Application for Planning Permission for Proposed Temporary Warehouse for Storage of Construction Materials (Timber and Metal) and Associated Filling of Land for a Period of 3 Years at Lots 123 RP, 124 (Part), 125 (Part), 126 (Part) and 127 (Part) in D.D. 113 and Adjoining Government Land, Ma On Kong, Kam Tin South, Yuen Long, N.T.
(Application No. A/YL-KTS/1147)

In response to the comments received from the Fire Services Department, we submit our response and a revised Fire Service Installations (FSIs) Proposal for your consideration.

Table 1: Responses to Departmental Comments (Application No. A/NE-KTS/1147) (2 October, 2026)

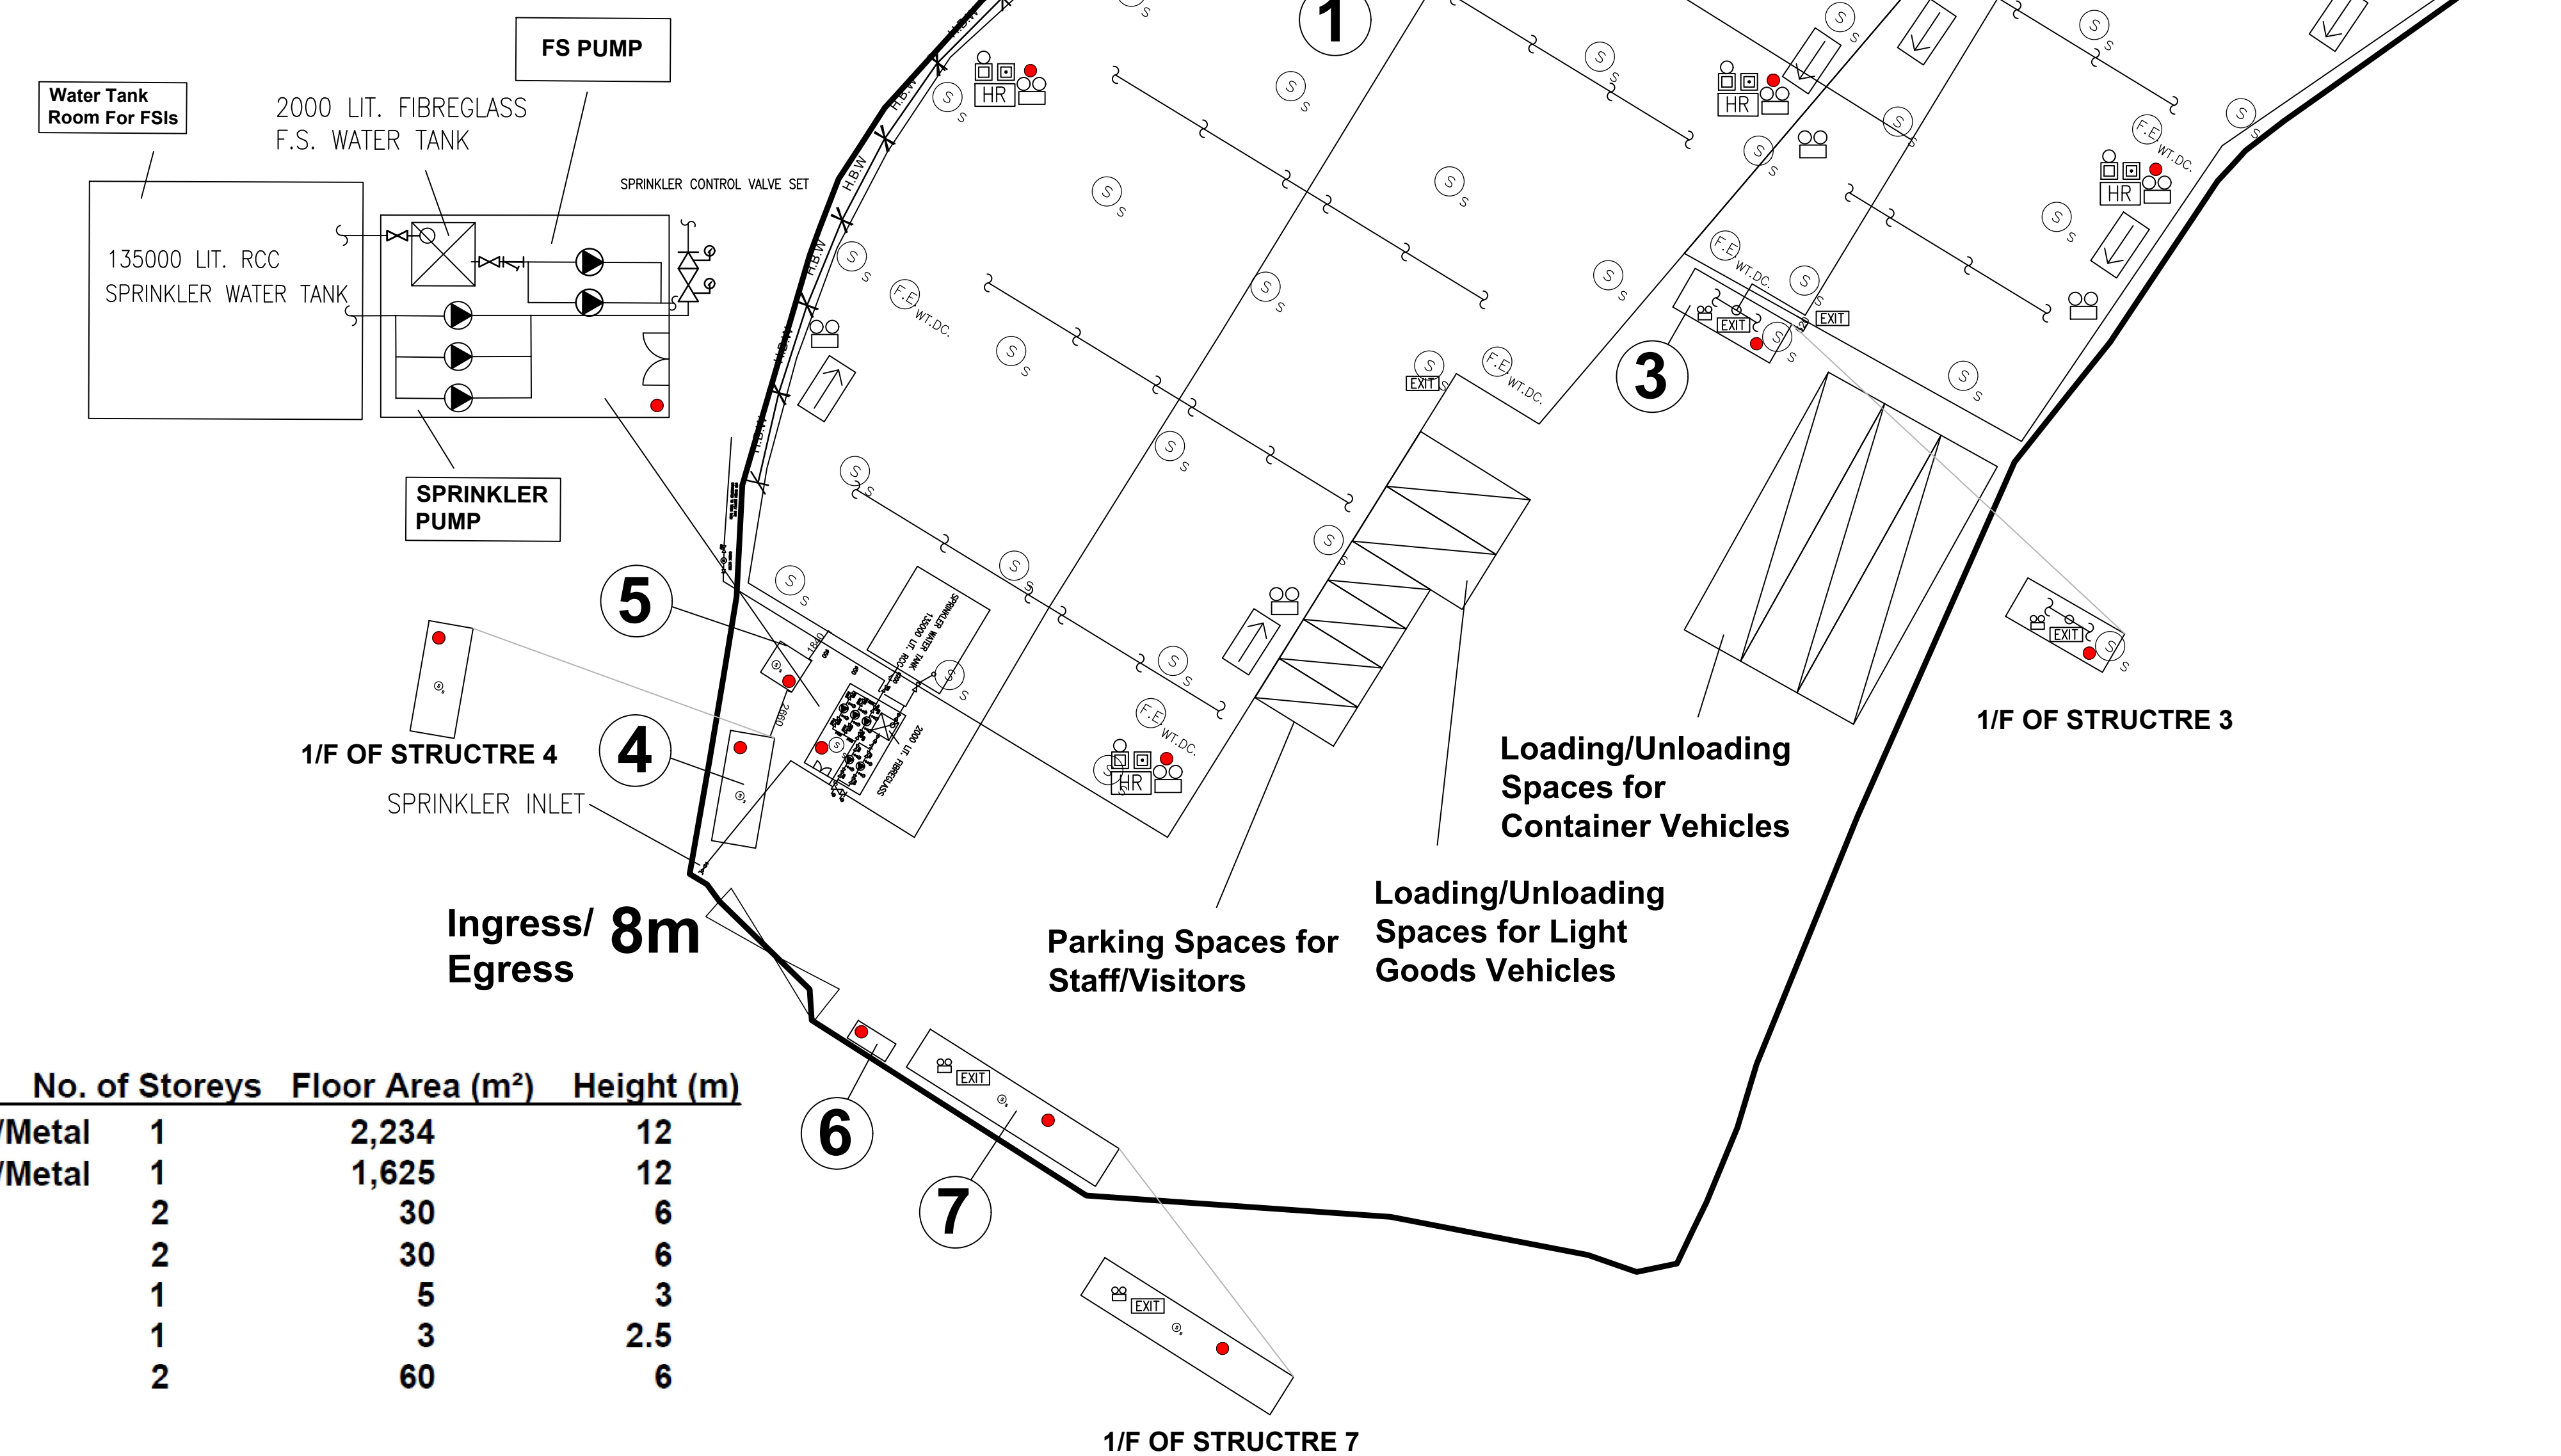
COMMENTS		RESPONSES
1.	Fire Services Department (Contact Person: Mr. YUEN Tsz-fung, Tel: 2733 7781)	
(i)	For enclosed structure with gross floor area not exceeding 230 m ² , i.e. FS Pump Room, portable fire extinguisher and stand-alone fire detector shall be provided;	Noted.
(ii)	A 20-35 kg wheeled type dry chemical fire extinguisher shall be provided in every 500 m ² on every floor of the premises and ensure that every part of the premises can be reached from a distance of not more than 30 m;	Noted. See F.S. Note 7.2.
(iii)	A sufficient number of wheeled type dry chemical fire extinguisher, emergency lighting and directional & exit signs shall be provided at Structures 1 & 2; and	Noted. A sufficient number of wheeled type dry chemical fire extinguisher, emergency lighting and directional & exit signs shall be provided at Structures 1 & 2.
(iv)	All accessible areas on 1/F of Structures 3, 4, & 7 are GFA accountable. In this regard, detailed layout plans with FSIs shall be provided for his further consideration.	Noted. Detailed layout plans with FSIs on 1/F of Structures 3, 4 and 7 are provided.
